**RABEAA POINT OF ENTRY
SCREENING FACILITY
RABEAA, IRAQ**

**SIGIR PA-09-173
JANUARY 11, 2010**

Rabeaa Point of Entry Screening Facility

Summary of Report: PA-09-173

Figure 1. Civil site plan (Courtesy of USACE)

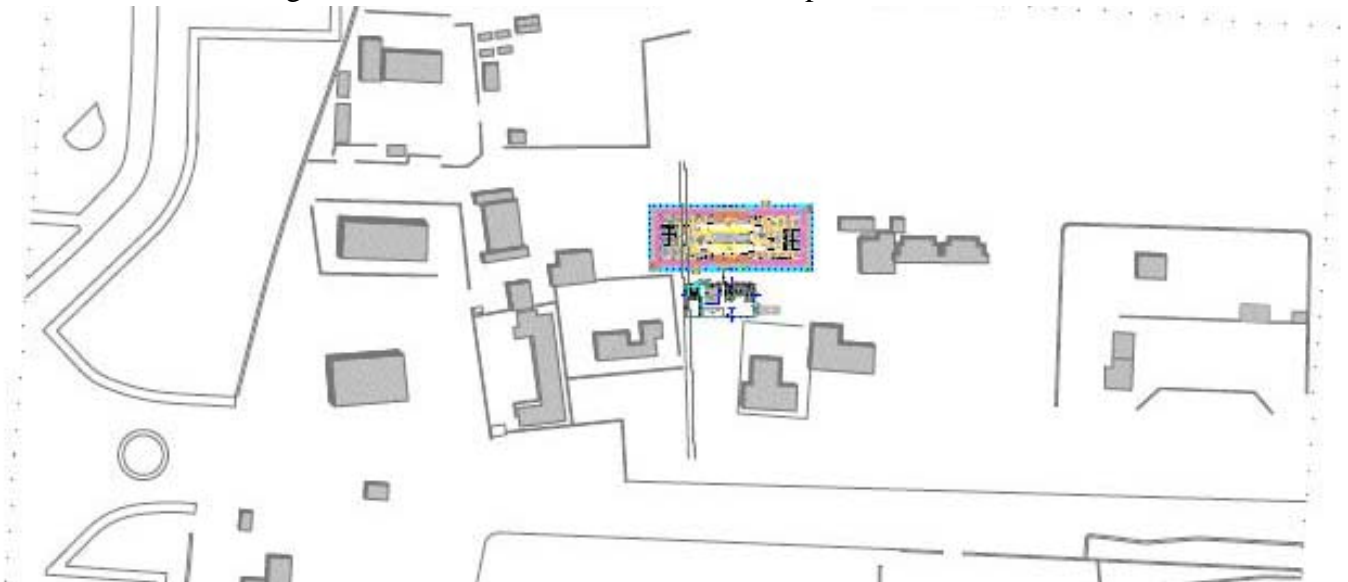
The civil design package included more architectural plans than civil drawings and the actual civil site plan (Figure 1) lacked details on topography, roadways, parking, and other typical site plan requirements. A primary concern was the lack of any drainage plan in the civil site plan. The contractor noted in the geotechnical report that drainage could contribute to future foundation problems.

Site Photo 5. Electrical conduit embedded in interior wall

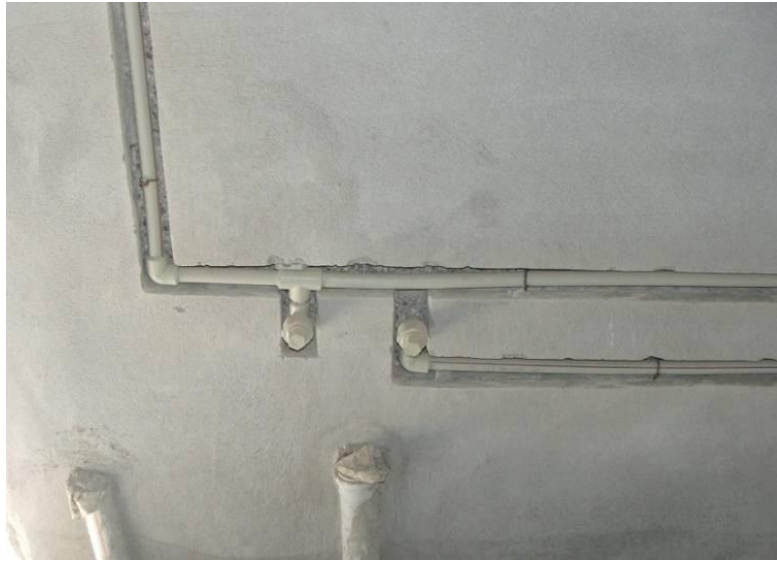
The conduit for future electrical wiring was embedded in the interior masonry walls (Site Photo 5). The SOW, Section 26.2.1 required that all building electrical lines were to be "surface mounted in conduit vice embedded." In addition, the conduit used did not match the COR approved product submittal.

Site Photo 6. "Pilsatherm" water pipes embedded along exterior wall

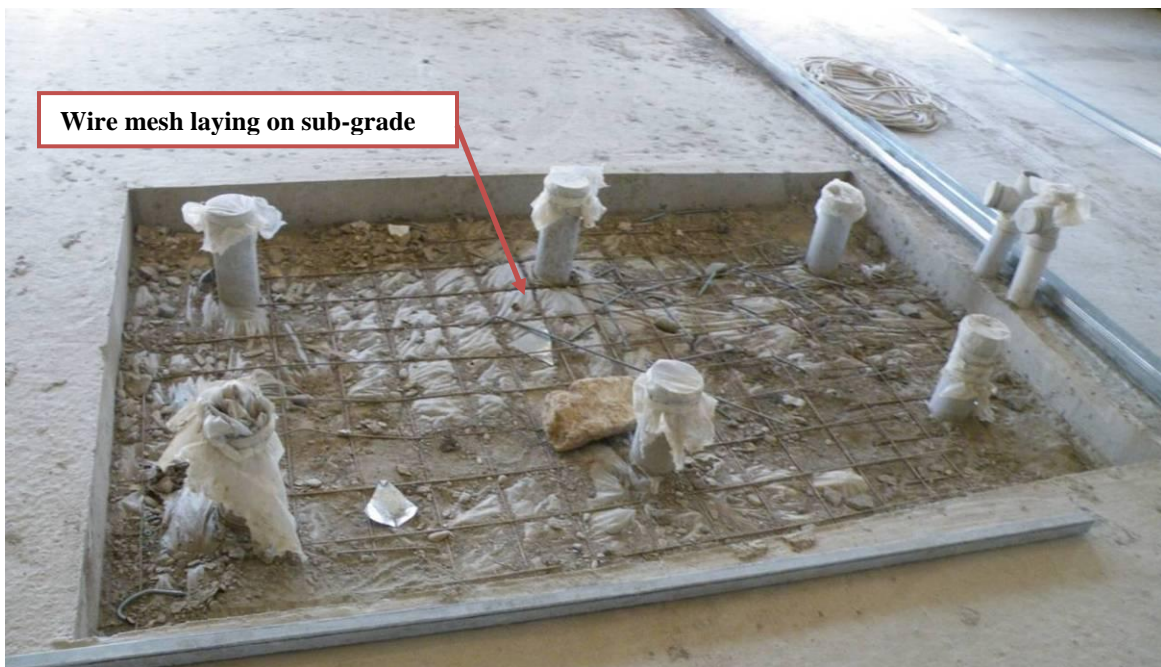
SOW, Section 22.5.3 required the contractor to use "schedule 40 galvanized steel pipes" and the water lines were to be surface mounted. The COR approved the use of a Turkish made product, pilsatherm (plastic) pipe, in a product data submittal. SIGIR noted that the COR approved a different water pipe product even though the pilsatherm pipe data submittal was unclear whether it met the International Plumbing Code standards as required by the SOW, Section 21.1.1. Also, the COR did not provide a contract price adjustment that should have been calculated when approving cheaper products and installation methods. At the time of the site visit, SIGIR noted that the potable water

lines were embedded in the masonry walls and were constructed using polypropylene (plastic) pipe (Site Photo 6).

Response: Concur. The resident office has addressed the variance. Resident office personnel directed the contractor to replace the pilsatherm pipes SIGIR documented during their review with galvanized steel pipes cited in the statement of work. See photos below.

Site Photo 8. Construction of mortar overlay on floor slab.

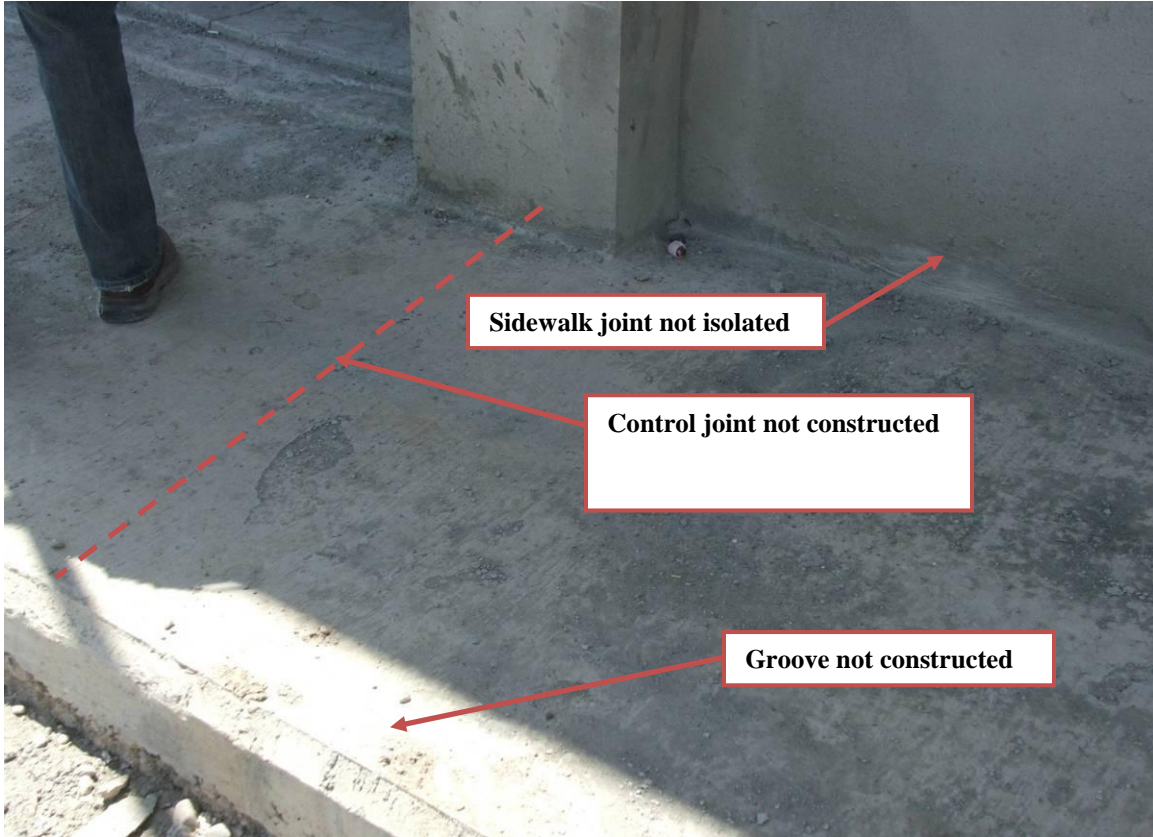
The concrete floor slab was constructed in two separate lifts (Site Photo 8). A thicker rough finish slab, estimated at 150mm thick, was poured throughout the building, except for areas where pipe penetrations were necessary. At the time of the site assessment, the contractor was starting to pour the second thinner mortar overlay, estimated to be 45mm thick, where the contractor was to lay the ceramic tile on top. SIGIR noticed that the construction of the floor slab showed improper jointing, unlevel construction, and cracking of the thin mortar overlay. In addition, SIGIR noticed from the missing sections of the floor slab that the wire mesh was laying on the sub-grade and was not lifted up properly (Site Photo 7).

Figure 5. Sidewalk detail per the 100% design drawings (Courtesy of USACE)

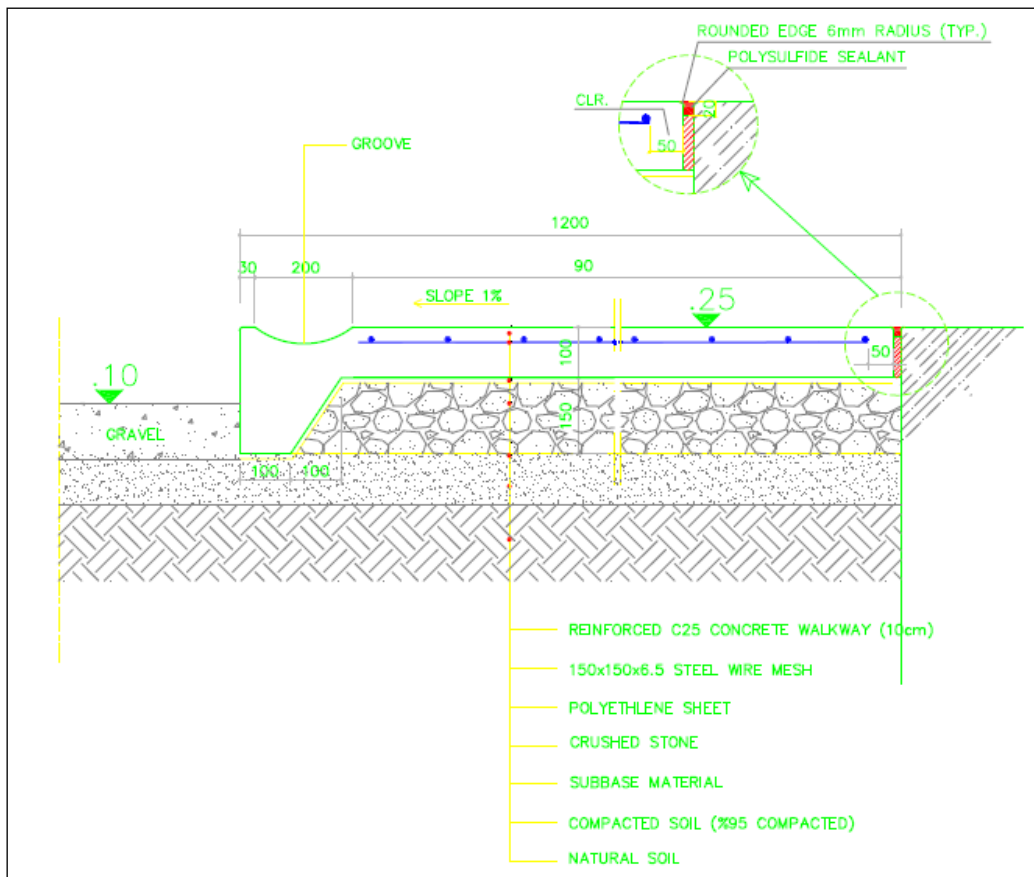
At the time of the site assessment, the exterior sidewalk was partially constructed; the construction was determined to be lacking an isolation joint next to the building, control joints, and a 200mm groove (Site Photo 9). Both the isolation joint and the groove were included in the 100% drawings submitted for approval (Figure 5). The control joints (contraction joints) were required every 1.2 meters (m) per a special note on the plans.

Figure 6. 100% Water pump room floor plan drawing (Courtesy of USACE)

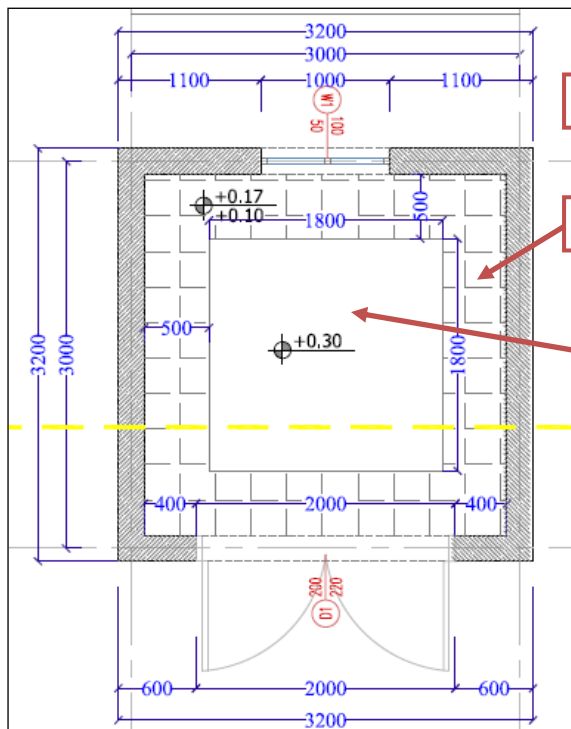
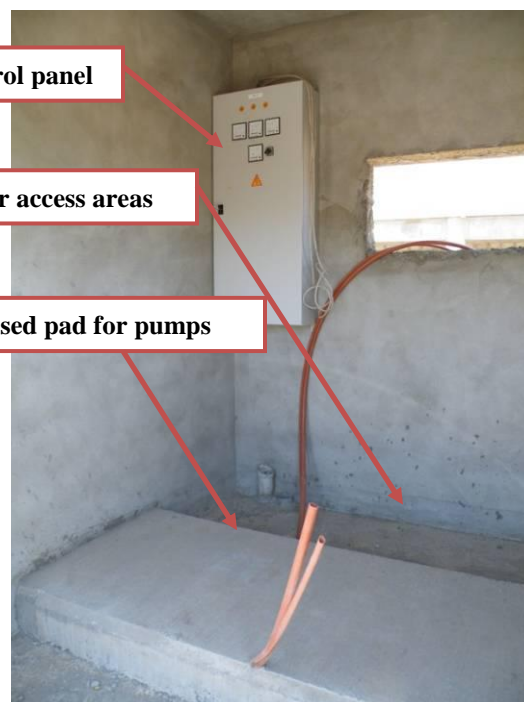
Although the construction of the water pump house was partially completed, SIGIR noted that the construction of the raised concrete pump pad was not constructed in accordance with the drawings (Figure 6 and Site Photo 10). Specifically, the raised floor as submitted on the plans was a 1.8m square raised concrete pad. The actual construction of the raised concrete pad was not configured in a square and did not allow for access against one exterior wall. Once the booster pumps are placed on the concrete pad, the access to the electrical control panel could be impeded. The original design allowed for unimpeded access all around the raised pump pad.
